Summary of Feedback Responses and Q&A

Stage 2 Develop and Assess

London Stansted Airport Future Airspace

Stage 2, Develop and Assess
Q&A – phase one engagement

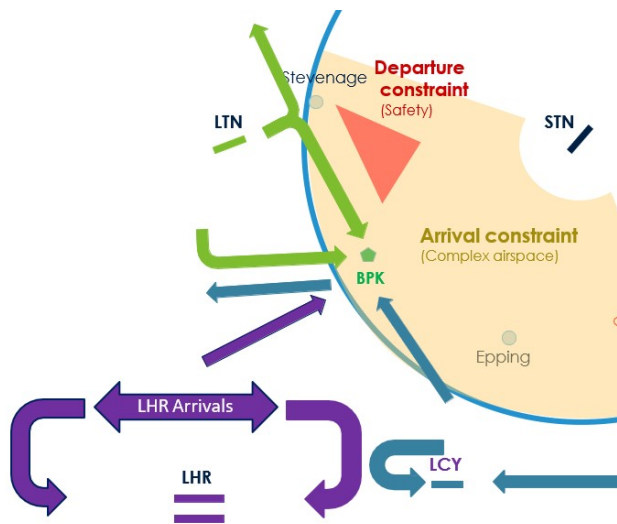
Q. I assume someone will be using the complex airspace to the southwest, so is it necessary to exclude all that airspace as not preferred?

We shared a diagram on the complexity in this area in the first phase of engagement but to help explain the constraint we have reproduced it below. It is also worth pointing out that we will be using part of that area to guide aircraft onto the final approach for runway 04 but at a height which is underneath the interactions that create the constraint. The constraint exists at the higher levels meaning we wouldn't start our arrivals at 7,000ft in this area.

The area where we've created the arrival constraint centres around the navigation beacon at Brookmans Park (BPK circled in red on the map). This is within our design boundary and is used as a point on departure routes from Luton, Heathrow and London City making this an area of highly congested airspace dominated by climbing traffic.

Looking into the future, the reliance on routing via this beacon will reduce as airports transfer to Performance Based Navigation (PBN).

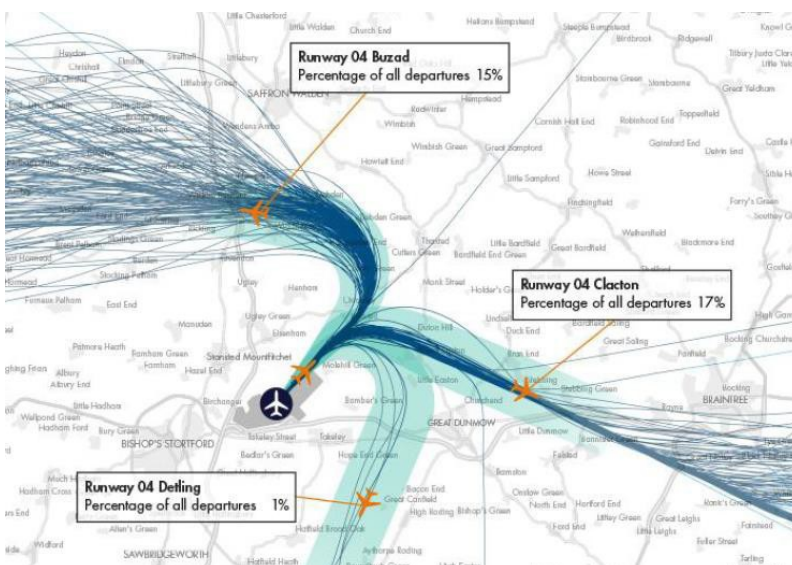
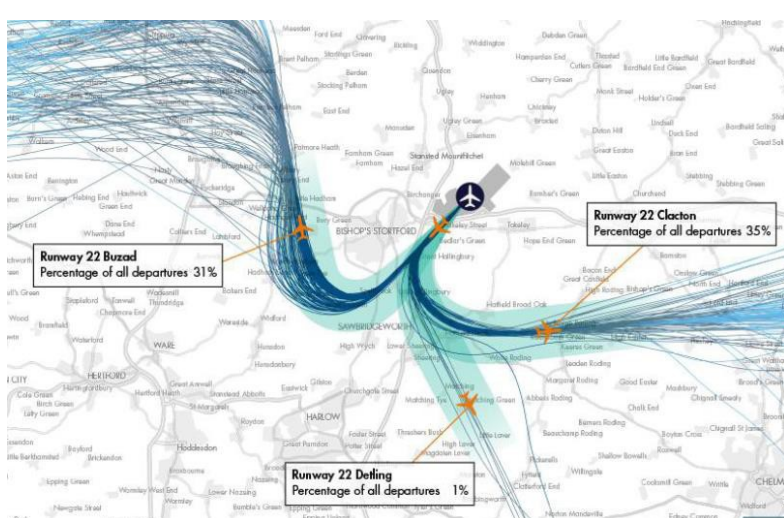
Q. What is the current % distribution of departures?

A. Typical summer traffic distribution is shown on the maps below which we shared with you earlier in the year. It should be noted that this distribution is based upon the current designs, and operational constraints that exist. One of the objectives of this project is to create a greater spread of traffic which links to the design principle N2 to create noise relief or respite. This may be created by additional routes which would change the percentage allocation on each route.
